Form 3160-5
(August 2007)UNITED STATES
DEPARTMENT OF THE INTERIOR
BUREAU OF LAND MANAGEMENTFORM APPROVED
OMB No. 1004-0137
Expires: July 31, 2010**SUNDRY NOTICES AND REPORTS ON WELLS**
**Do not use this form for proposals to drill or to re-enter an
abandoned well. Use Form 3160-3 (APD) for such proposals.**

8. Well Name and No.
Rock Queen Unit # 0309. API Well No.
30-005-00891

Permit Procedure Rock Queen #30 30-005-00891

**Rock Queen Unit 30
30-005-00891
Chevron USA Inc.
July 8, 2025
Conditions of Approval**

Current WBD (4/7/2025)

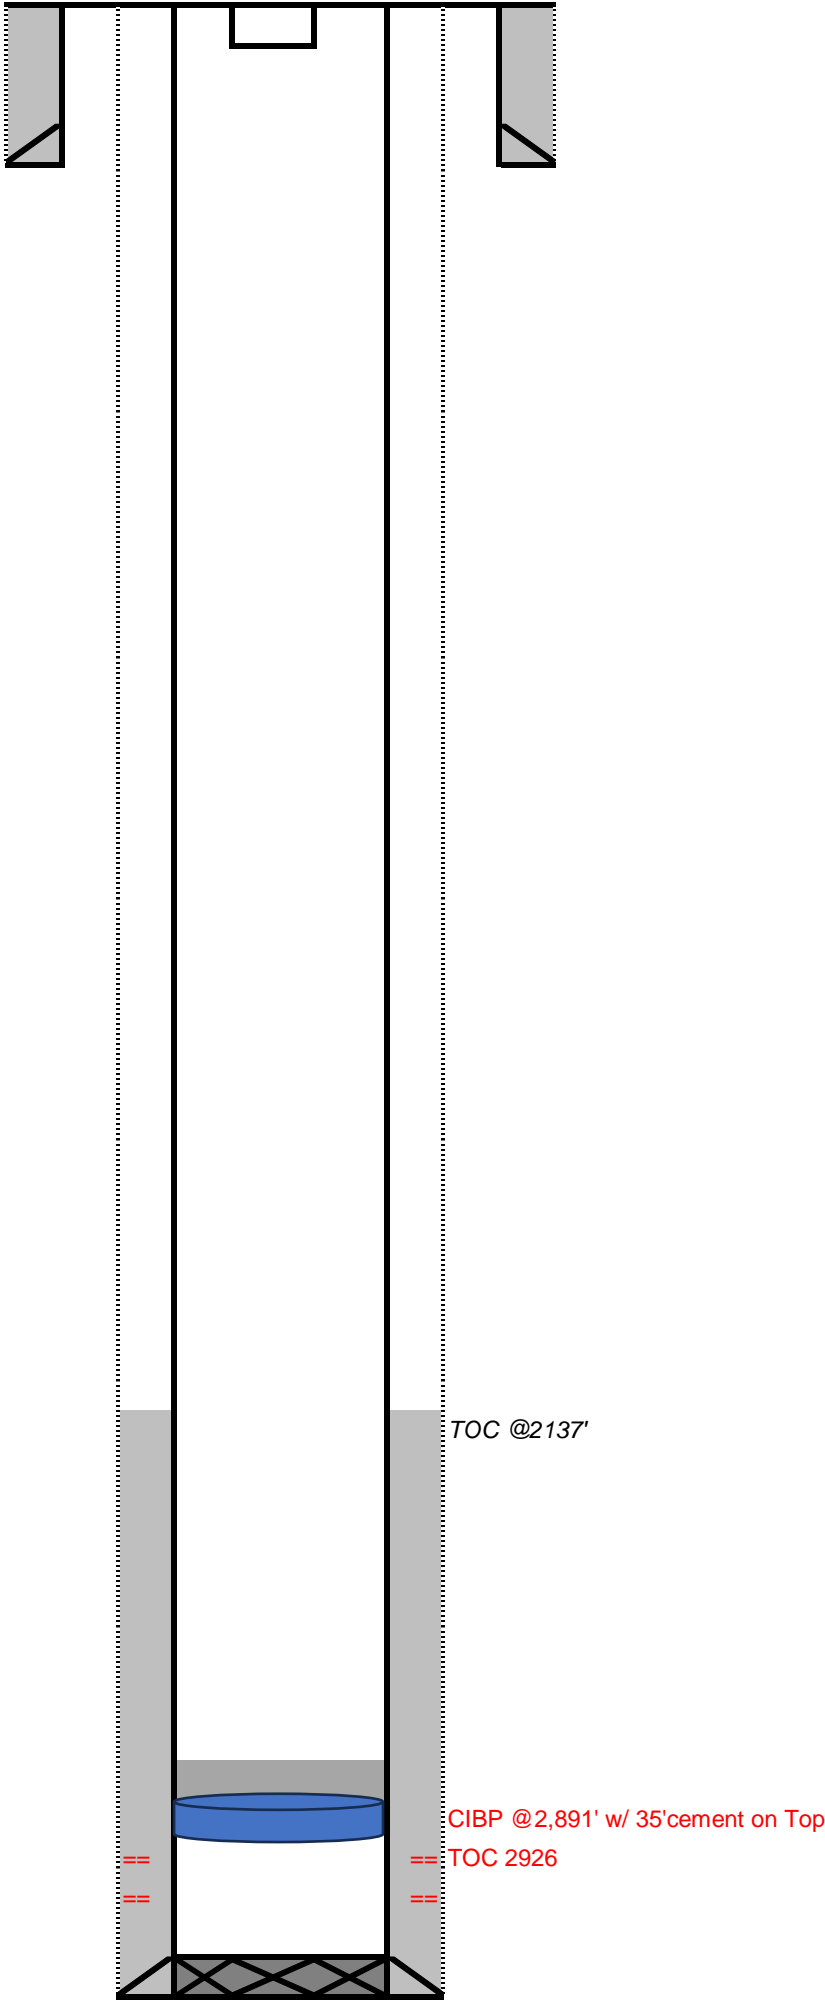
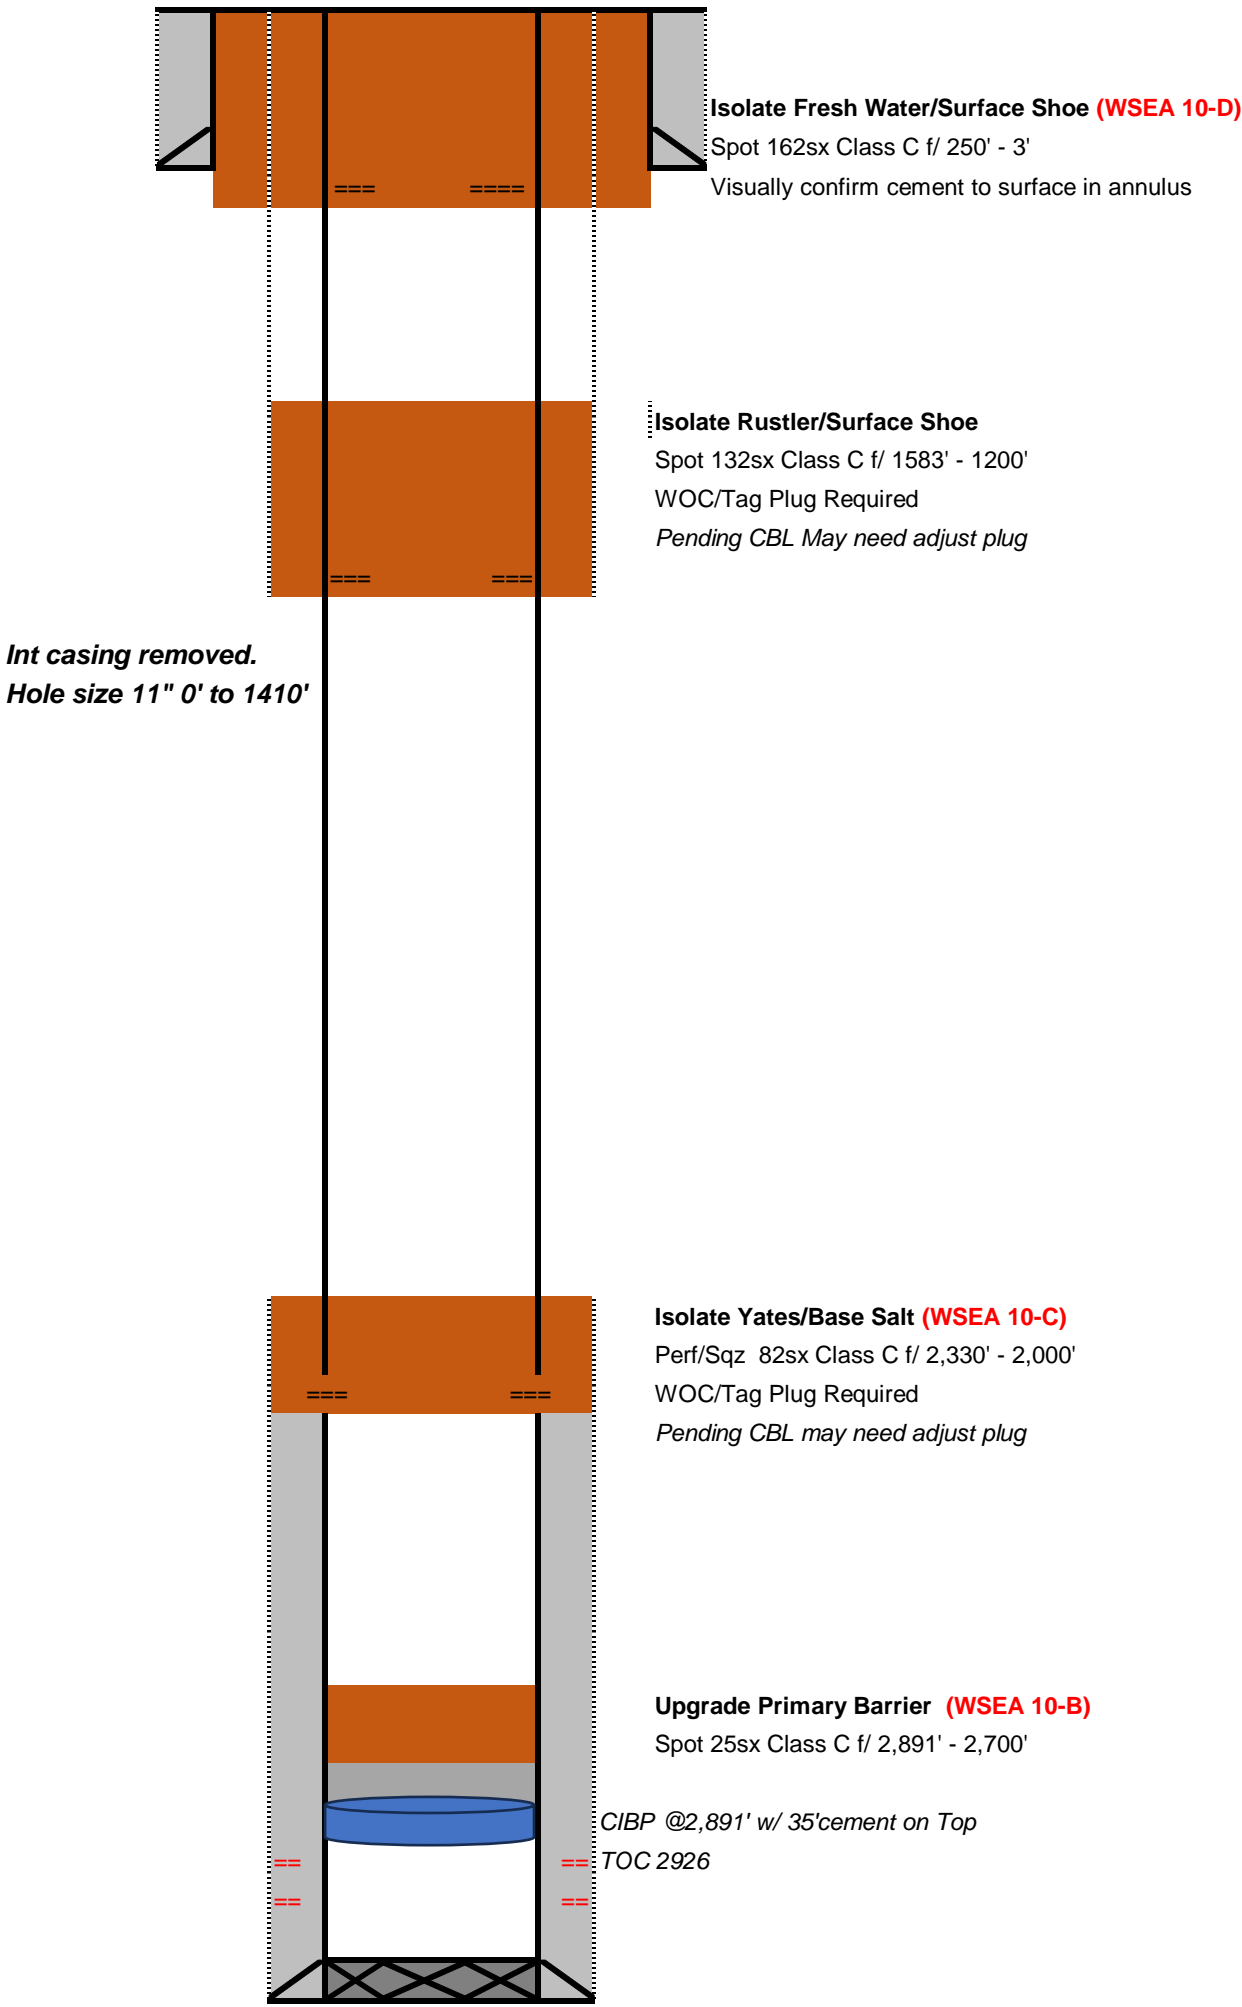
1. Operator shall tag CIBP. Operator shall place 25 sx Class C cement on top of CIBP. WOC and TAG.
2. Operator shall perf at 2,330' and squeeze cement class C cement to 2,000' to seal the Yates and bottom of Salt. WOC and TAG.
3. Operator shall perf at 1,583' and squeeze cement class C cement to 1,200' to seal the top of Salt and Rustler. WOC and TAG.
4. Operator shall perf at 250' and squeeze cement class C cement to surface to seal the 13-3/8" casing.
5. Dry hole marker must be below ground.
6. Surface reclamation will need to be completed once the well bore has been plugged. Please contact rflores@blm.gov for additional information.
7. See Attached for general plugging stipulations.
